Access Compliance Report

Public Rights-of-Way

Intersection ID: 12089	Main Street: E_12TH_ST	Cross Street: N_DAVIDSON_ST	Location: S
ADA ID: 2F37EC3ACA63	Ramp Type: Perp	Initial Pass/Fail: Fail	Overall Compliance: No
		Severity Score: 25

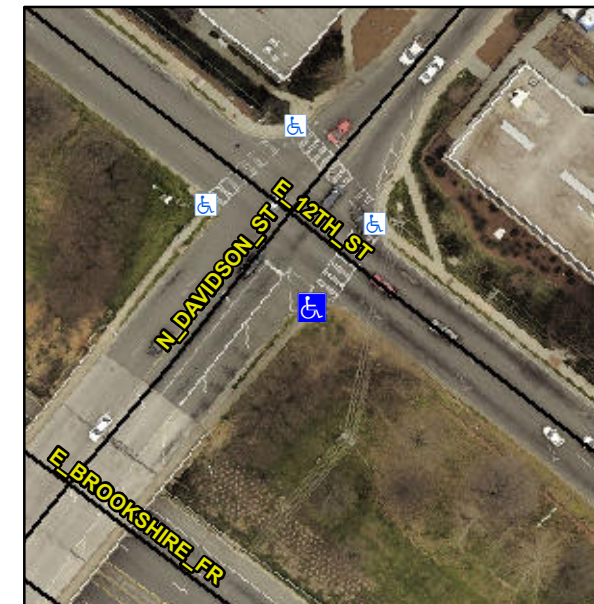
Not Found, R304.5.3

Compliance	Description	Data	Compliance	Description	Data
N/A	Ramp Length (in)	60.0	Yes	Ramp Slope (%)	5.1
Yes	Ramp Width (in)	51.0	No	Ramp XSlope (%)	8.0
N/A	Flare Type LT	N/A	N/A	Flare Type RT	N/A
N/A	Flare Slope LT (%)	N/A	N/A	Flare Slope RT (%)	N/A
N/A	Flare Traversable LT?	N/A	N/A	Flare Traversable RT?	N/A
N/A	Landing Length (in)	N/A	N/A	DWS Provided?	N/A
N/A	Landing Width (in)	N/A	N/A	DWS Contrast?	N/A
N/A	Landing Slope (%)	N/A	N/A	DWS Length (in)	N/A
N/A	Landing X Slope (%)	N/A	N/A	DWS Full Width?	N/A
N/A	Landing Curb? (Y/N)	N/A	N/A	DWS Offset (in)	N/A
N/A	Shared Landing?	N/A			
N/A	Gutter Ponding?	N/A	N/A	Gutter Slope (%)	N/A
N/A	Gutter Lip Ht (in)	0.5	N/A	Gutter X Slope (%)	N/A
N/A	Painted X Walk1?	Yes	N/A	Painted X Walk2?	N/A
	X Walk 1 Direction	To NE		X Walk 2 Direction	N/A
N/A	X Walk 1 Width (in)	143.0	N/A	X Walk 2 Width (in)	N/A
	X Walk 1 Slope (%)	1.2		X Walk 2 Slope (%)	N/A
	X Walk 1 X Slope (%)	10.9		X Walk 2 X Slope (%)	N/A

Remove & Replace Entire Ramp.
